Work Order ID 82729

Item Name: Crosstube Fwd

DRAWING NO. D407-667-145	TITLE CROSSTUBE ASS'Y (407 HIGH FWD)	REV. C	DART AEROSPACE LTD ENGINEERING ORDER		D.E.O. NO. D407-667-145-C-1	SHEET NO. SHEET 1 OF 1	SCALE NTS
DRAWN 47	CHECKED ASS	MFG. APPR. 18	APPROVED WD		DE APPR. H		
DATE 11.07.15	DATE 11.07.22	DATE 11.07.22	DATE 11/07/22		DATE 11.07.21

REPLACE MAGNOBOND WITH PROSEAL.

DESIGN	40	DART AEROSPACE LTD
DRAWN	RF	HAWKESBURY, ONTARIO, CANADA
CHECKED	40	DRAWING NO. REV. C
MFG. APPR.	40	D407-667-145 SHEET 2 OF 4
APPROVED	40	TITLE SCALE
DE APPR.	40	CROSSTUBE ASS'Y (407 HIGH FWD) NTS
DATE	08.11.06	COPYRIGHT © 2002 BY DART AEROSPACE LTD

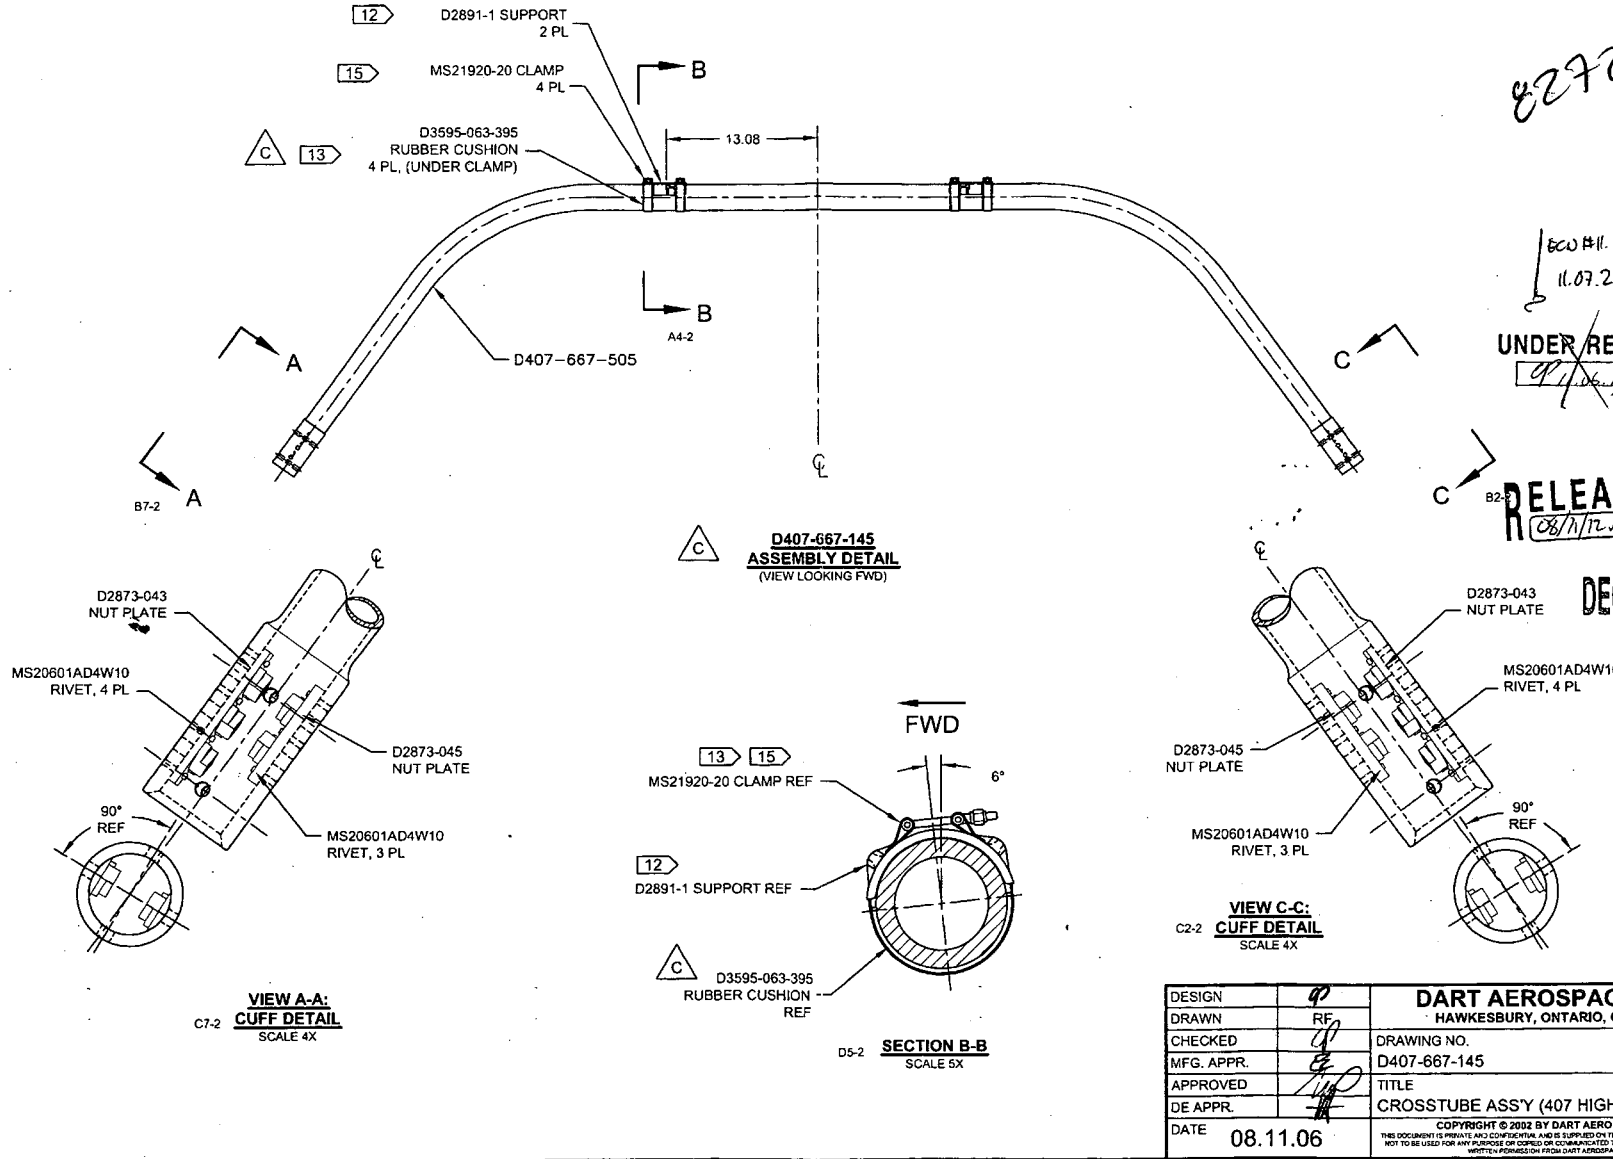
IS:

Item	Qty -145	Part Number	Description
9	A/R	PROSEAL 890 B-2	SEALANT, AMS-S-8802 CLASS B-2

WAS:

9	A/R	MAGNOBOND 6398	ROCKWELL SPECIFICATION RBO-120-023 ADHESIVE (TEXTRON/BELL SPEC. 299-947-100, TYPE II, CLASS 2 ADHESIVE)
---	-----	----------------	---

NOTE 12 & 15, SHEET 1 IS AMENDED AS FOLLOWS:

- 12) TO INSTALL D2891-1 SUPPORT: ABRAD MATING SURFACE OF SUPPORT AND CROSSTUBE WITH 180-GRIT SANDPAPER AND REMOVE RESIDUE WITH MEK (OR EQUIVALENT). APPLY A 0.04" TO 0.07" THICK LAYER OF PROSEAL 890 CLASS B-2 (OR AMS-S-8802 CLASS B-2) SEALANT TO MATING SURFACE OF SUPPORT.
- 15) TORQUE CLAMPS 80 TO 100 IN-LB. ENSURE AT LEAST 1.5 THREADS SHOWING IN SAFETY AND THAT NUT HAS NOT BOTTOMED-OUT AFTER TORQUING. **PRIOR TO PACKAGING, RE-CHECK TORQUE ON CLAMPS AFTER PROSEAL 890 SEALANT HAS CURED FOR 72 HOURS.**

- 12) INSTALL D2891-1 SUPPORT USING 0.03" TO 0.06" THICK LAYER OF MAGNOBOND 6398 PER QSI 015. LET CURE FOR 12 HOURS AFTER INSTALLATION AND PRIOR TO PACKAGING.
- 15) TORQUE CLAMPS 80 TO 100 IN-LB. ENSURE AT LEAST 1.5 THREADS SHOWING IN SAFETY AND THAT NUT HAS NOT BOTTOMED-OUT AFTER TORQUING.
